Staff Report

To: Salt Lake City Planning Commission
From: John Anderson, Senior Planner
(801) 535-7214 or john.anderson@slcgov.com
Date: September 26, 2018
Re: PLNSUB2018-00570: Moda Main Planned Development

PLANNED DEVELOPMENT

PROPERTY ADDRESSES: 1566 - 1576 S. Main St.
PARCEL ID: 16-18-155-006, 16-18-155-007 and 16-18-155-008
ZONING DISTRICT: CC Corridor Commercial
MASTER PLAN: Central Community Master Plan – Community Commercial

SHEET NUMBER:
D101.1

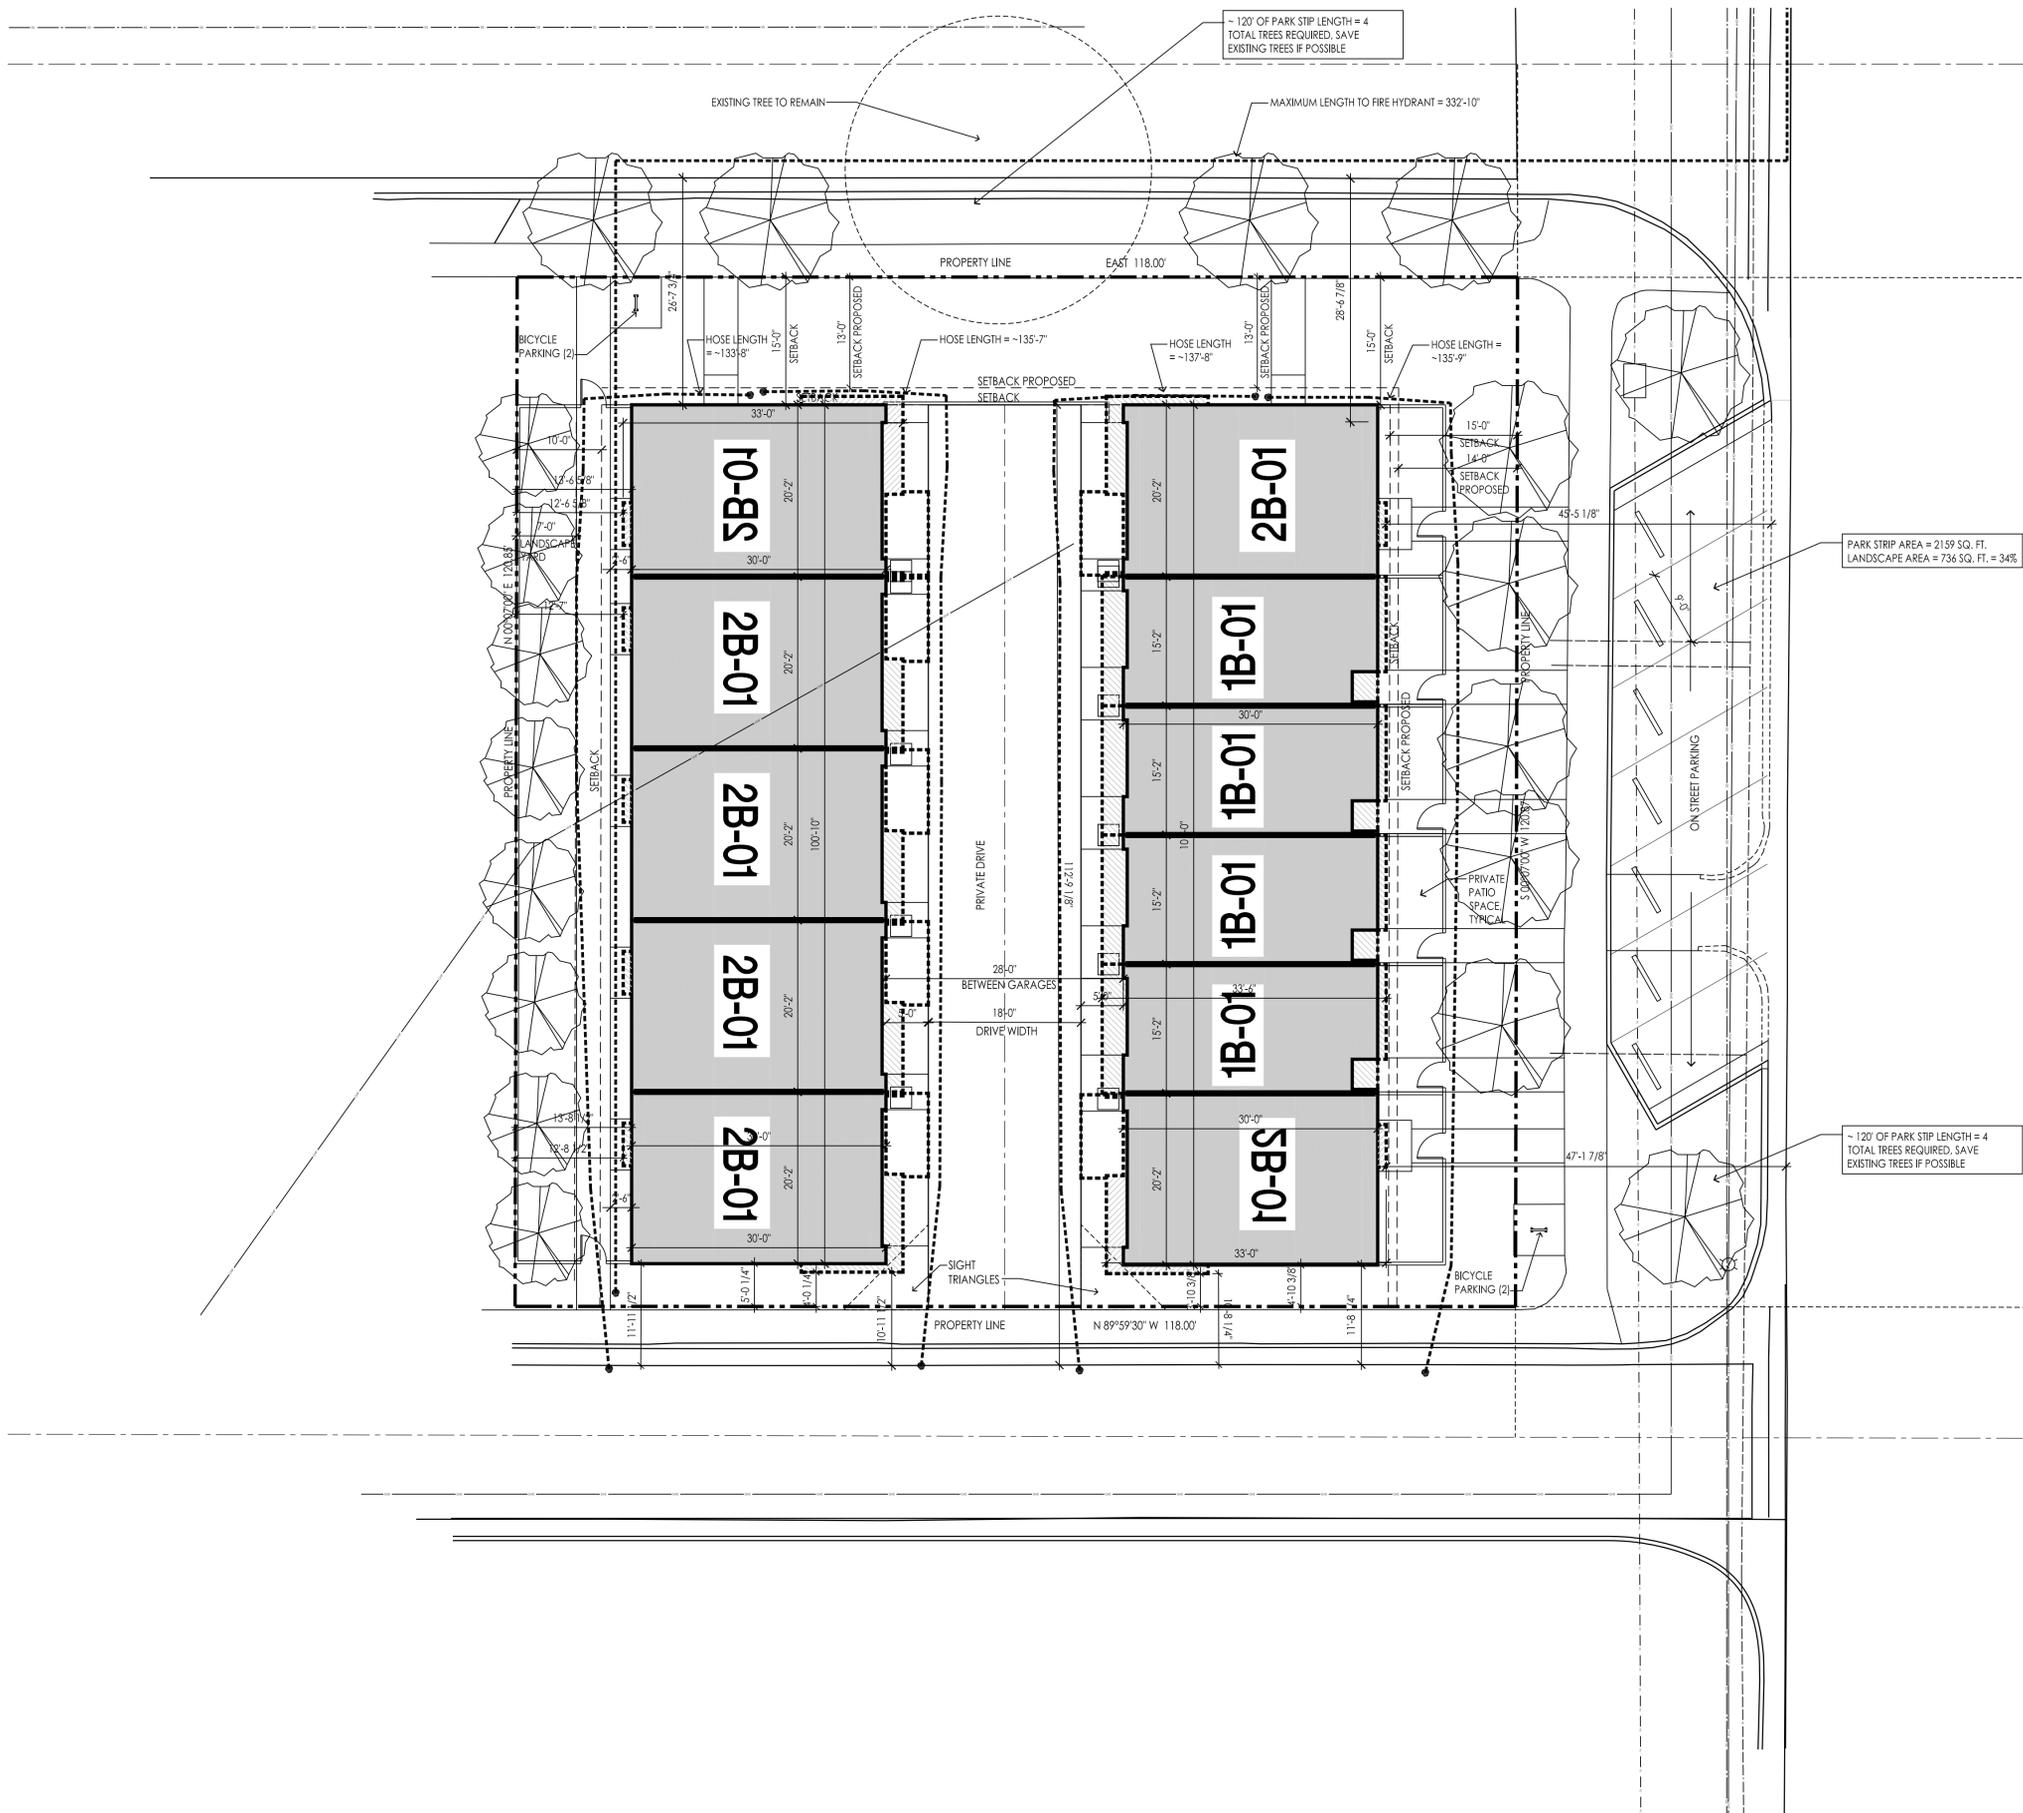
- 3) The planned development will need to address the reduction of the required 15 feet setback to 3.25 feet along Harris Avenue, and how the required CC landscaping will be addressed in the reduced setback area.

- 5) Bay windows, balconies and awnings that encroach into required setbacks will need to be addressed by the planned development, or they shall comply with table 21A.36.020.B, for Obstruction in Required Yards.

D301

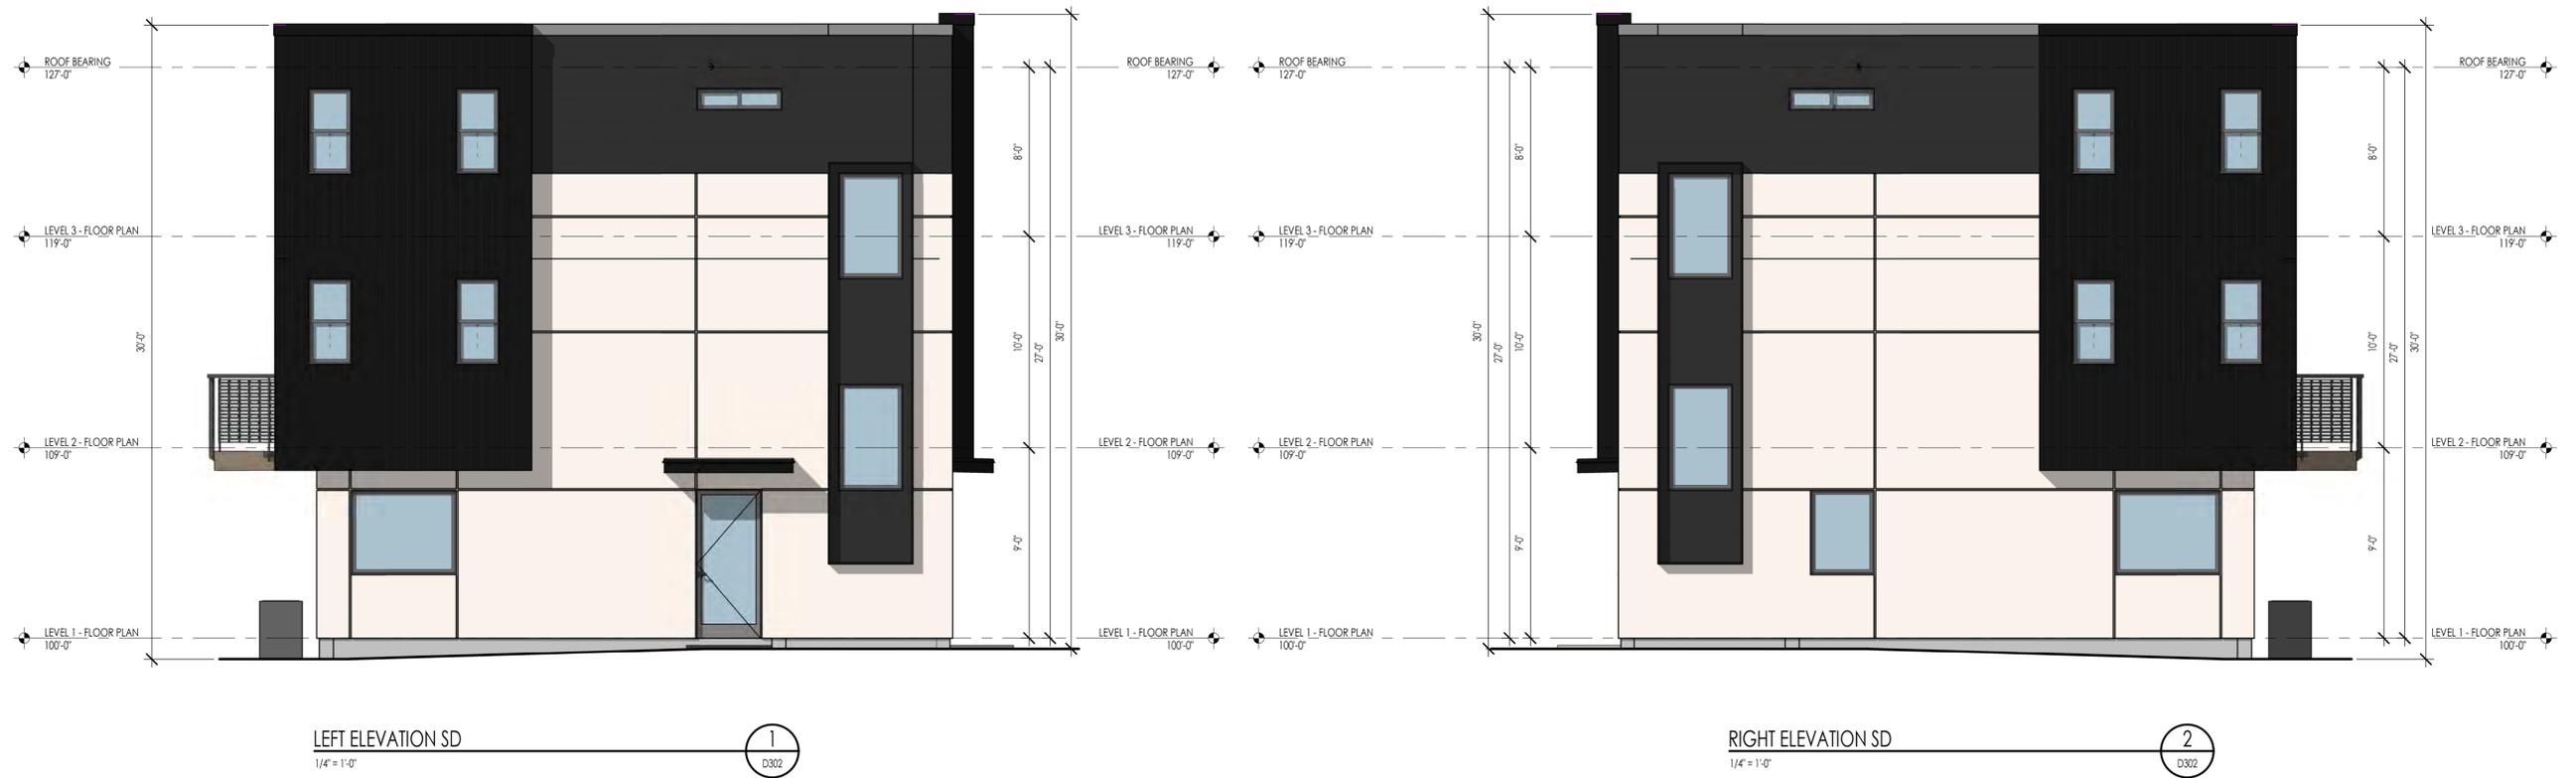
- At least one operable building entrance on the ground floor is required for every street facing facade. There are currently no entrances on Harris Ave. or Van Buren Ave. Please make changes to the elevations demonstrating compliance with this standard or request a modification through the Planned Development process (21A.37.050.D)
